ADDENDUM

23085 Fargo Public Library Sunshades Replacement

RE: Addendum #01

Issued: June 1, 2023

SHEET
E200
FIRST FLOOR
ELECTRICAL PLAN

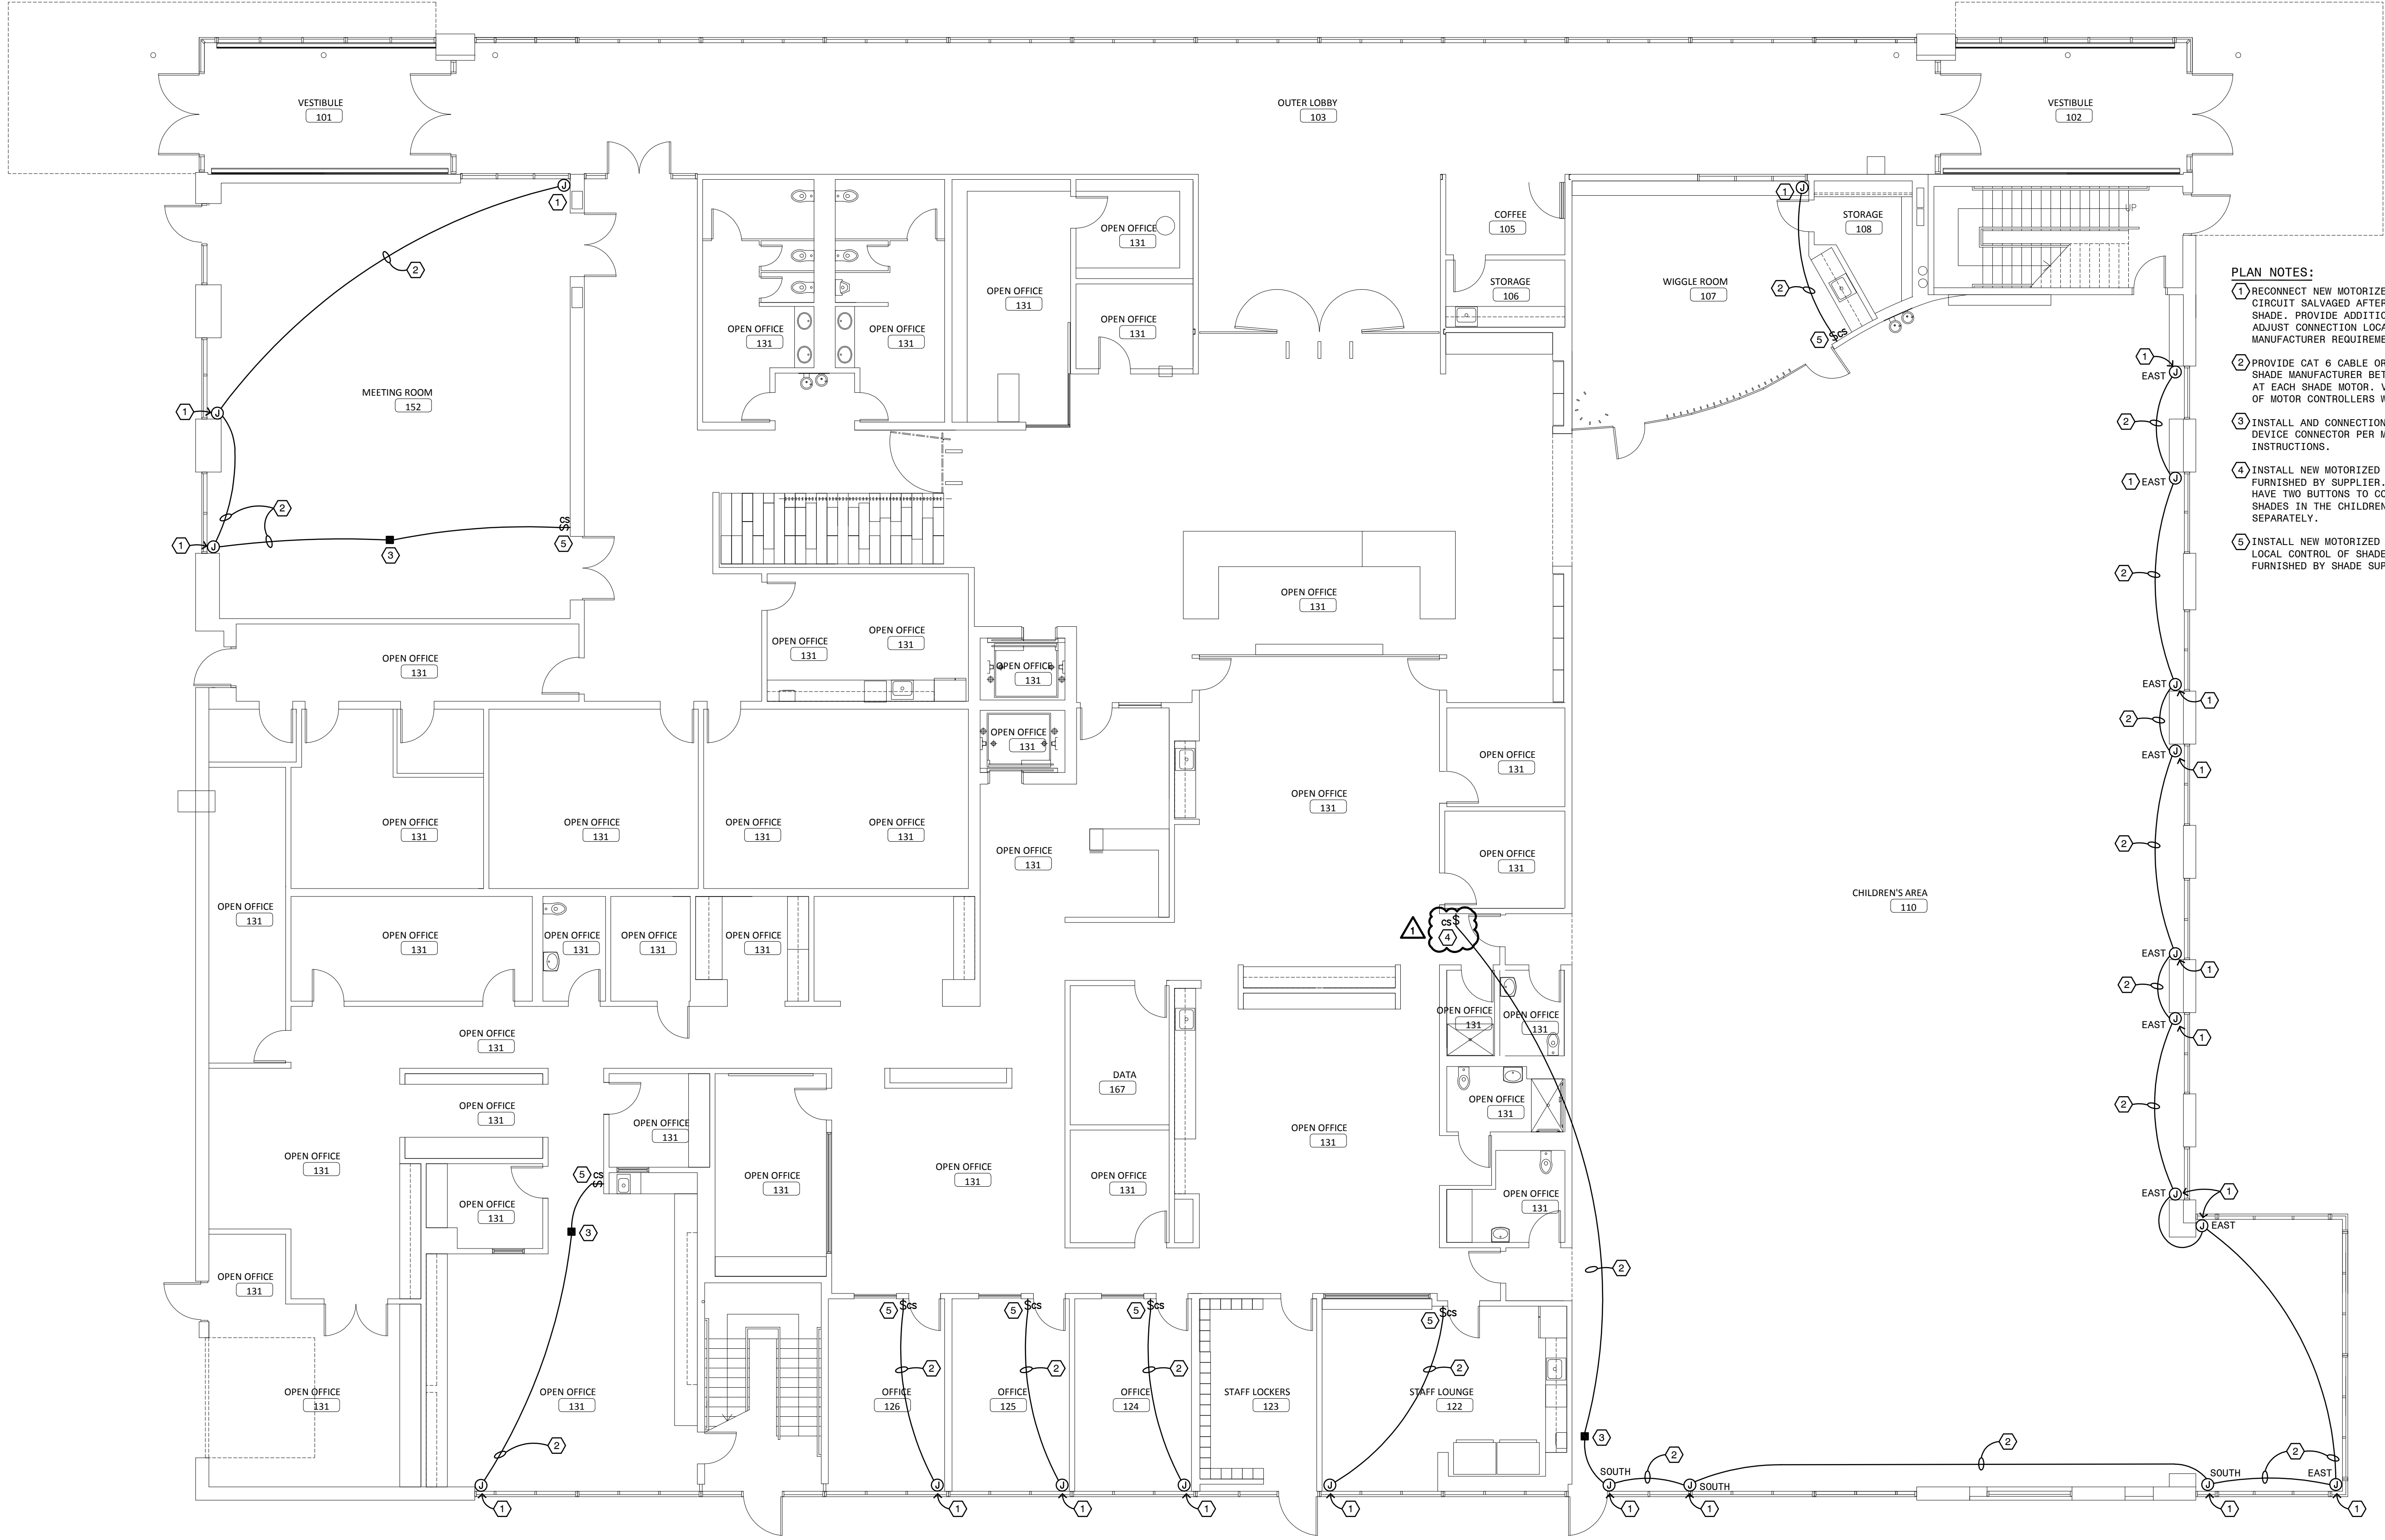
- The control station for children's area 101 is to be relocated to room 131. Refer to Electrical Addendum #01 items.

1. The control station for children's area 110 is to be relocated to room 131. See attached revised drawing E200 for updated location.
